REMARKS

Summary of the Office Action

Summary of the Response to the Office Action

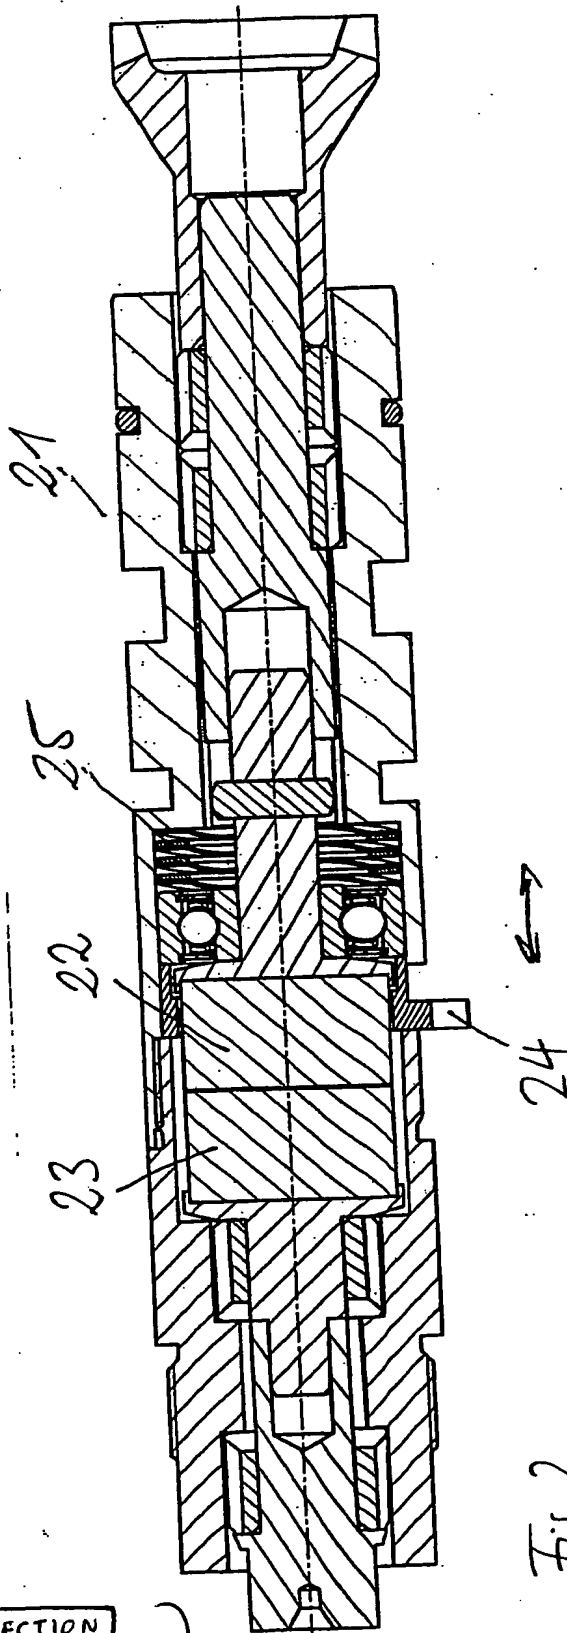
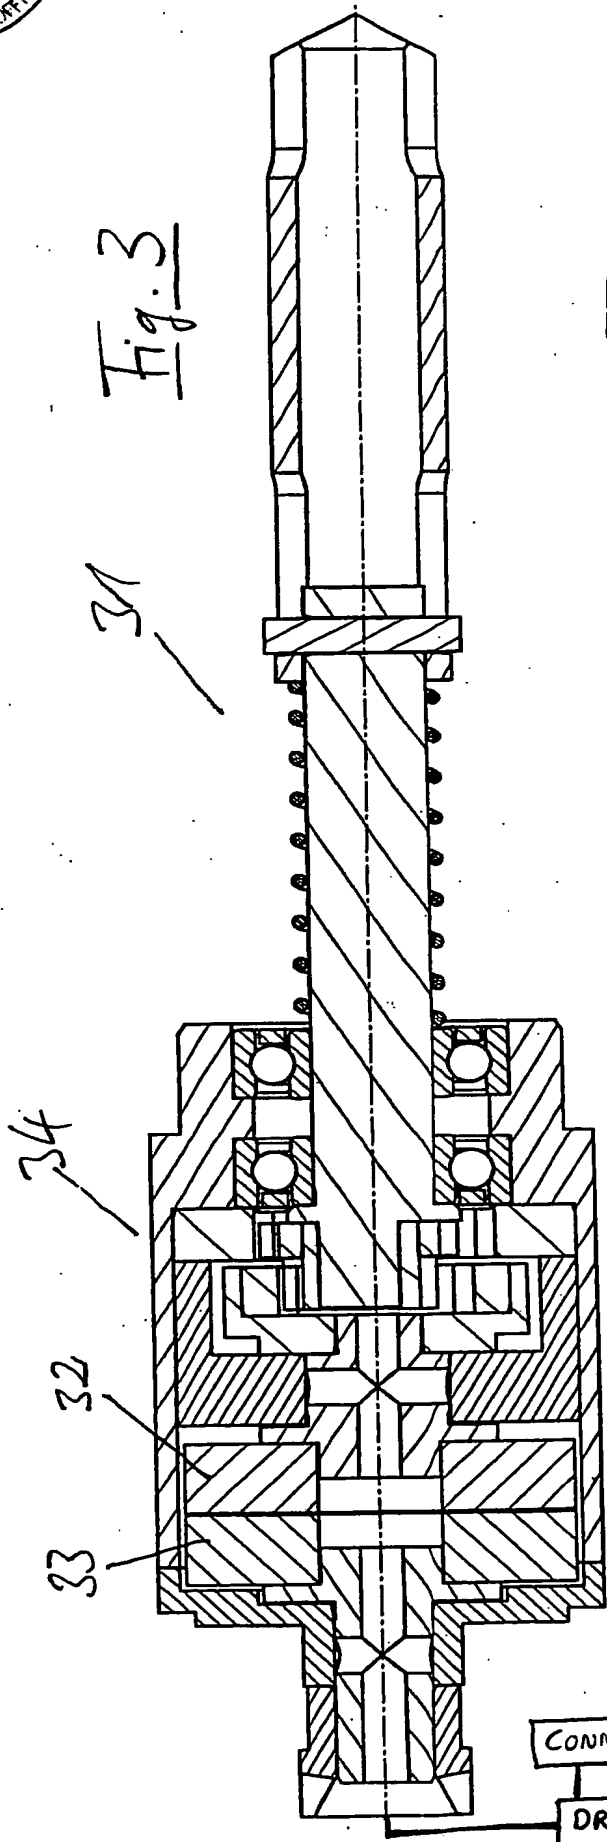
With regard to dependent claim 12, the Office Action states that the limitations of “a neck drive,” “a drive motor with high rotation speed,” and “a reduction gear,” must be shown. With regard to the aforementioned objection, Applicant respectfully asserts that the limitation of the neck drive 1 is shown in original Fig. 1a, the limitation of the drive motor is now shown in amended Fig. 3, and the limitation of reduction gear 34 is shown in original Fig. 3.

With regard to dependent claim 18, the Office Action states that the limitation of “a connection point is provided on a motor,” must be shown. With regard to the aforementioned objection, Applicant respectfully asserts that the aforementioned limitation is now shown in amended Fig. 3.

CONNECTION POINT
DRIVE MOTOR

FIG. Label Added.
